Product Change Notification(PCN)

Attachable heatsink for TO-220 (2010 catalogue page 445)

Change Notification # : PCN 20130611-V6534x-T

V6534A / V6534B / V6534E1

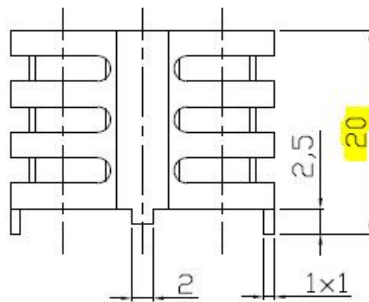
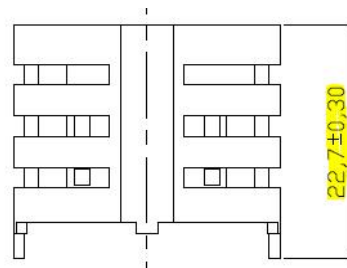
1. Amendment of the specification
2. Change of ASSMANN WSW ordercode :
Old : V6534A New : V6534A-T
Old : V6534B New : V6534B-T
Old : V6534E1 New : V6534E1-T
3. Change of production plant
4. Correction of overall height : NEW : 22.7±0.3mm
5. Draw.-No. ASS 2100 HSrev02 substitutes ASS 1001 HSrev00
